Date: 18 March 2024
Our ref: 60065/09/SPM/SRo/28889495v1
Your ref: PP-12736063

Application for Non-material Amendment to Reserved Matters Approval ref. 15238/23

Plot 3, Wingates Industrial Estate, Great Bank Road

Figure 1 Comparison of the Approved External Lighting Plan (left) and the Proposed (right). Proposed external lights are identified EX3.

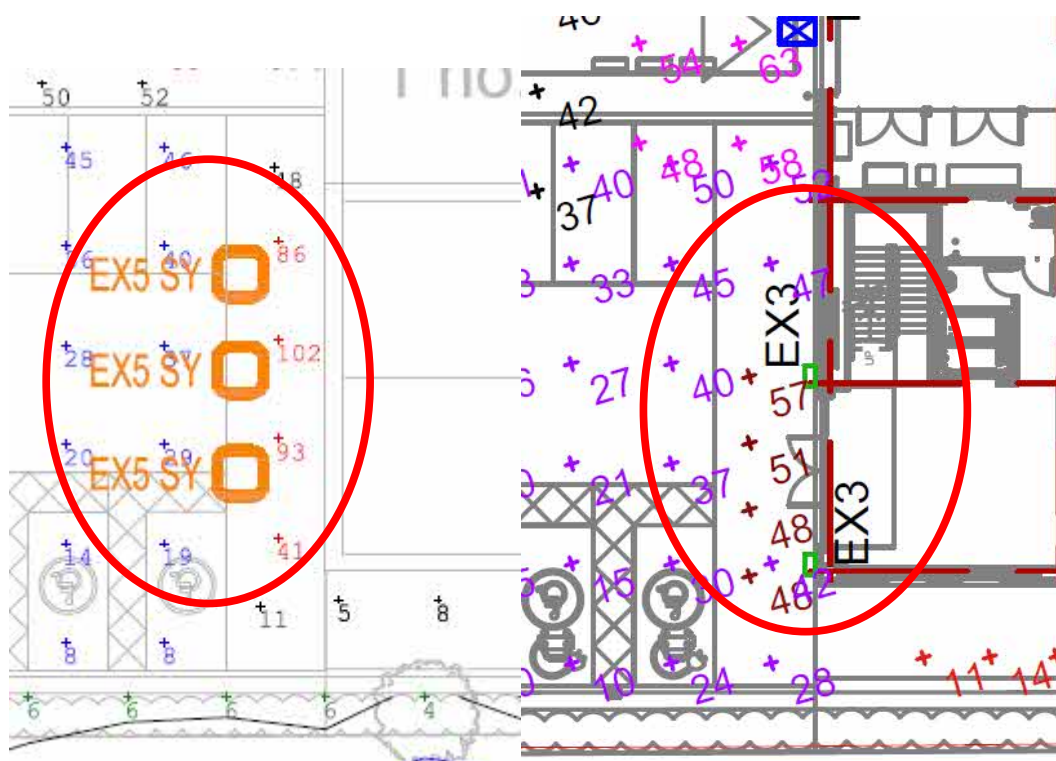
With regards to the external lighting of the main entrance, the two proposed wall mounted fixtures (EX3) will project from the western elevation of Unit 3 and will illuminate the ground below. Please refer to a comparison of the approved and proposed lighting plans in Figure 1 below. The levels of illumination are detailed on the Unit 3 External Lighting and Lux Plot Layout Plan, a snippet of which is used in Figure 1 (ref. P23012-EBM-EX-XX-DR-E-0931 rev. P2). This demonstrates the illumination

level of the proposed projecting light fixtures will be lower than the level of illumination of the lighting bollards. The illumination levels of the approved lighting bollards can be found on the Proposed External Lighting Layout which was submitted with the RMA (ref. 220512 rev. P01). The level of illumination will remain sufficient for users of the site during times of darkness. The proposed lighting fixtures will therefore reduce light emissions. The proposed projecting light fixtures are also considered to frame the entrance to the building, offering an improved way finding function for visitors, and negate the need for bollards in the public realm areas. On this basis it is considered that the wall mounted light fixtures will not result in adverse amenity impacts for the residents located to the north of the site on Wingates Grove but will continue to serve their purpose by illuminating the main entrance. This change is clearly non-material.
